Australian War Memorial Redevelopment

Request to accept a Variation of a proposal (2019/8574) pursuant to section 156A of the EPBC Act

Attachment 1 – Change project area and disturbance areas

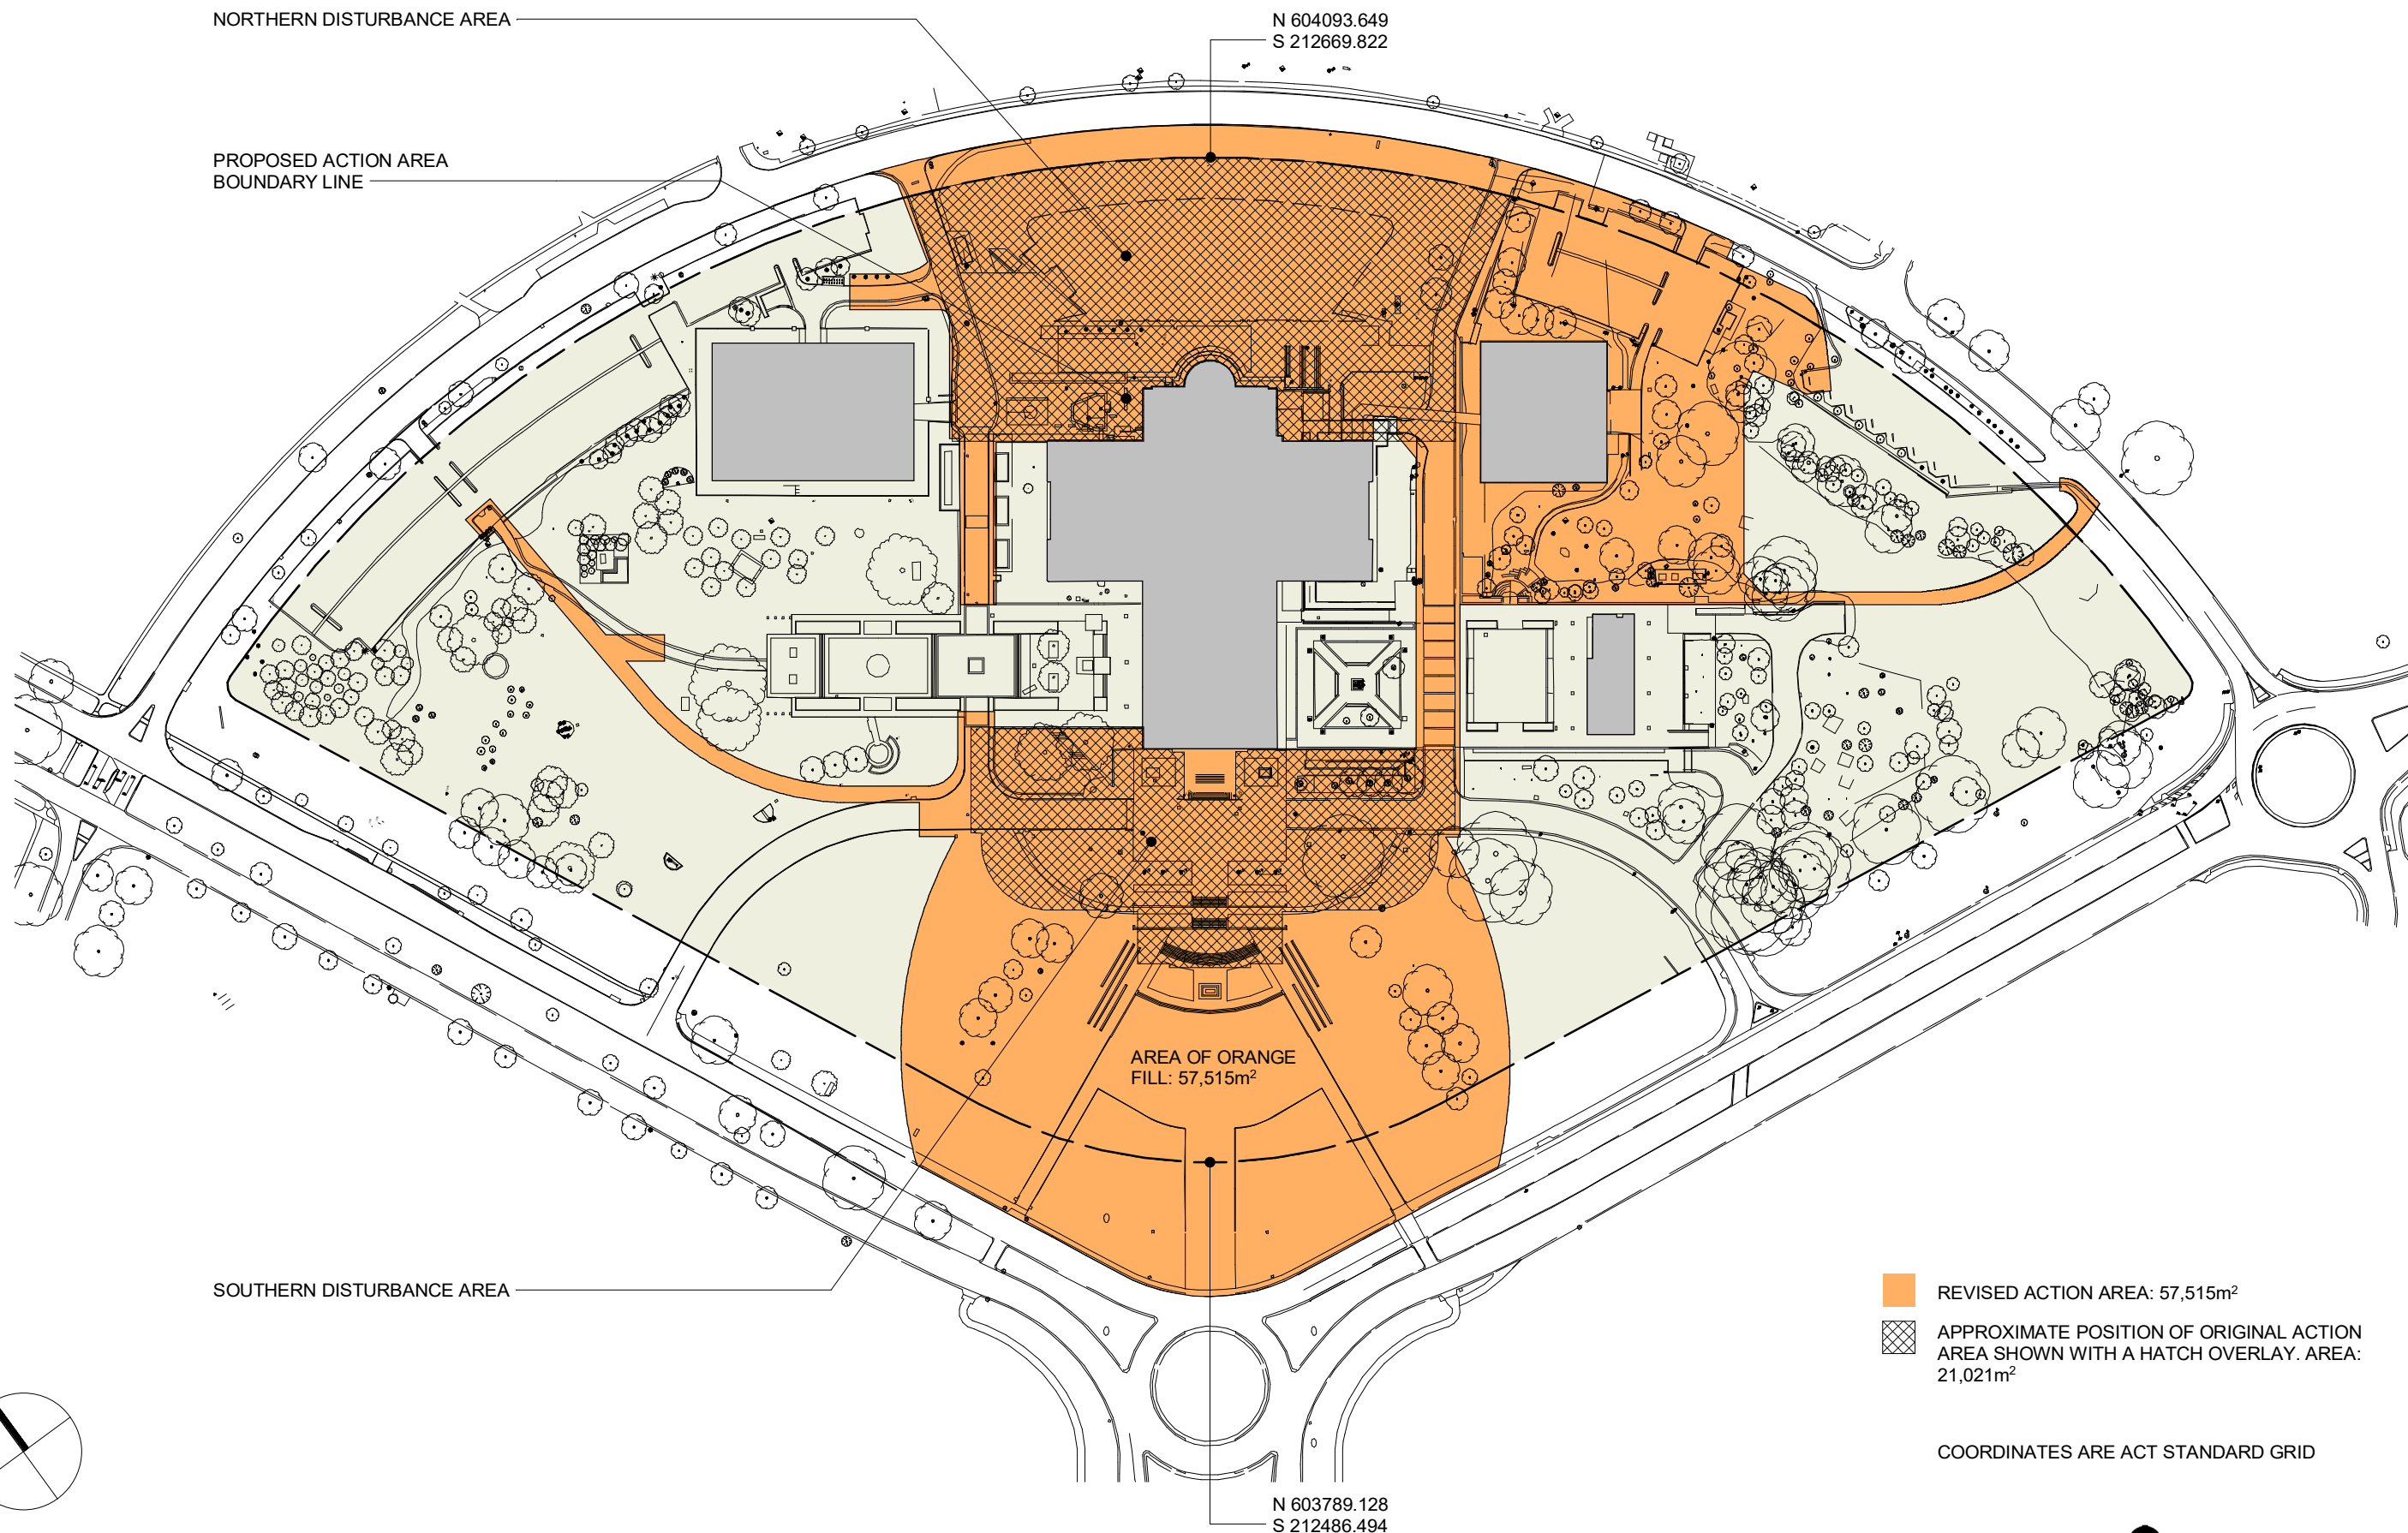
The revised referred project area is relatively consistent with the original referred project area with the exception of the C.E.W. Bean Building extension and refurbishment, C.E.W Bean Research Centre and primary works within the precinct Public Realm to support the redevelopment. The action area site plan is provided in **Attachment 1** and shows the original referred project area and additional areas considered as part of this variation.

Item	Proposed Action	Area (m ²)
1	C.E.W. Bean Building extension and refurbishment	5,115 (internal area) – new construction works 2,943 (across level 1,2 and 3) – refurbishment works

Item	Proposed Action	Area (m ²)
2	C.E.W. Bean Research Centre	867 (internal area) – new construction works
3	Public Realm improvements	<p>To support the redevelopment the following Public Realm works are proposed:</p> <ul style="list-style-type: none"> • changes to the western surface carpark; • installation of new paths from the western and eastern surface carparks to the new Southern Entrance; • upgrades to the western and eastern roads; and • changes to the profile of the parade ground into a rectangular shape.

Drawing SK005(A) – Public Realm Plan

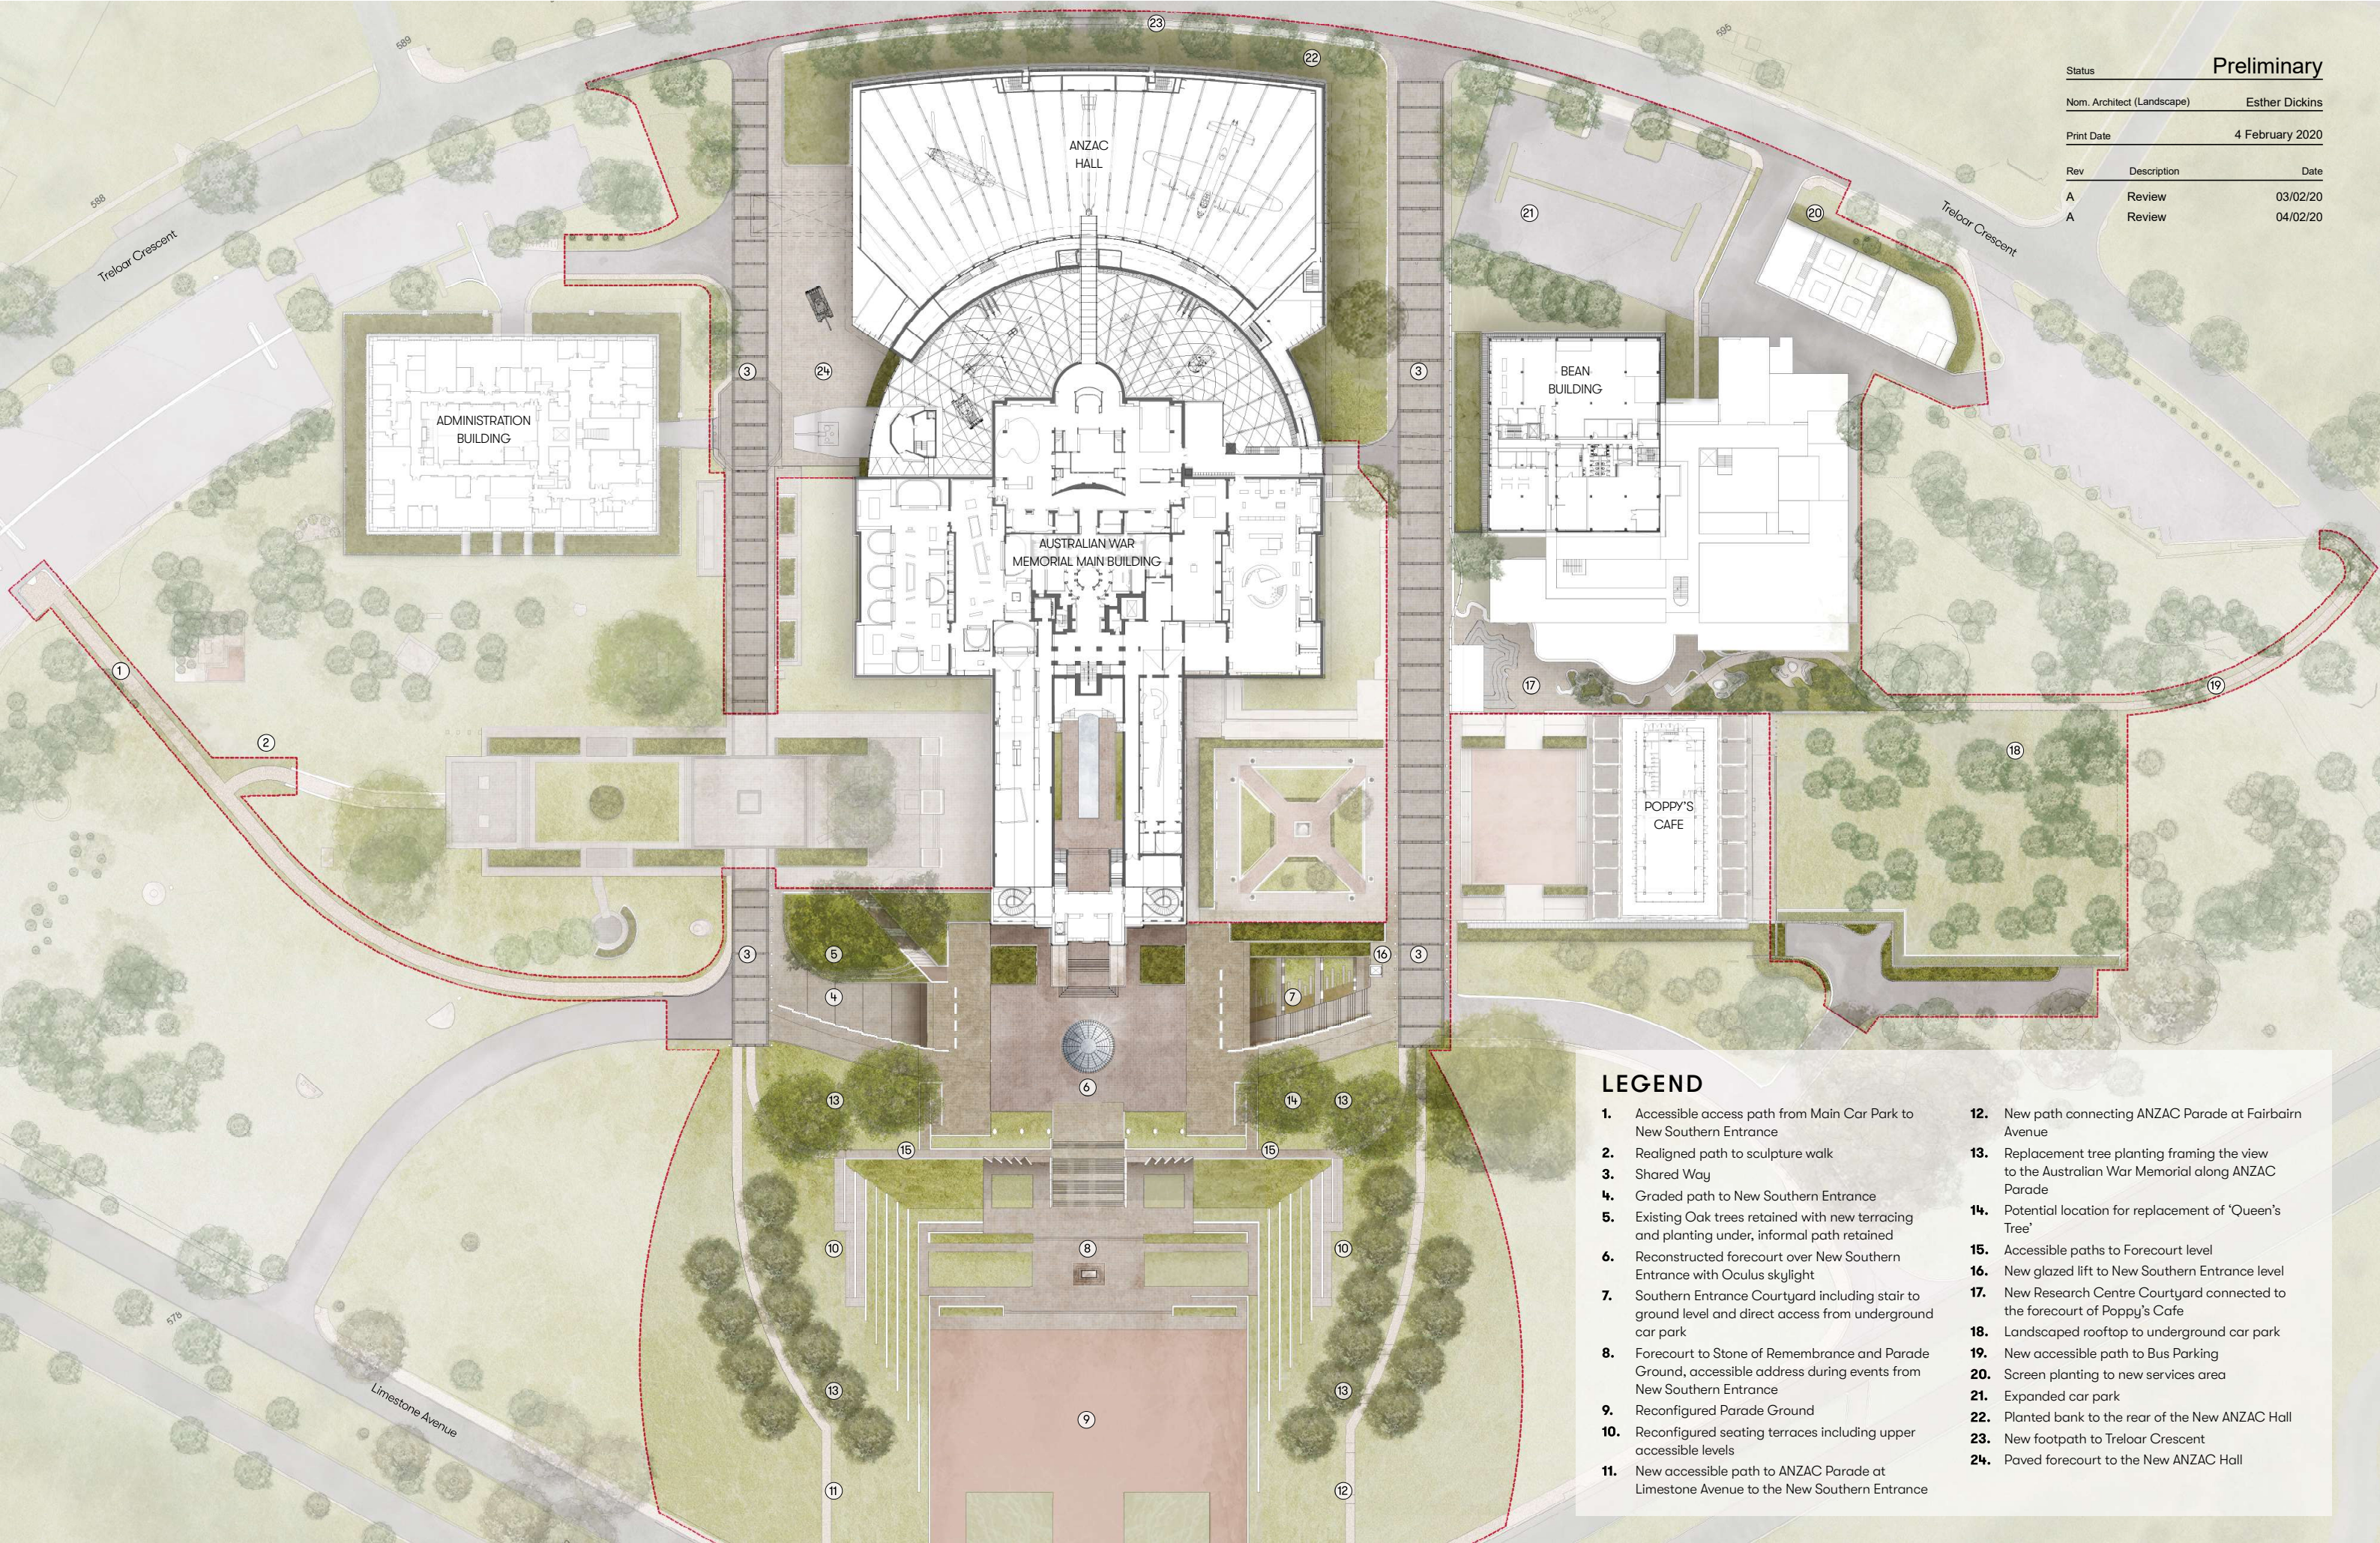
- **Public Realm improvement works** – precinct Public Realm works, including:
 - changes to the western surface carpark to make the main route to the Memorial entrance more intuitive;

- a new path from the western surface carpark to the new Southern Entrance which will enable a safe journey for visitors in all weather, and complies with all relevant requirements to provide disabled access;

- a new path from the tour bus parking area through to the education entrance which will remove the requirement for buses to park along the eastern road, improving safety and the connectivity of the precinct;
- conversion of the western and eastern roads to shared zones to improve the pedestrian experience; and
- changes to the profile of the parade ground into a rectangular shape more suitable for ceremonies, consistent with other military parade grounds, and better respecting the north-south axis.
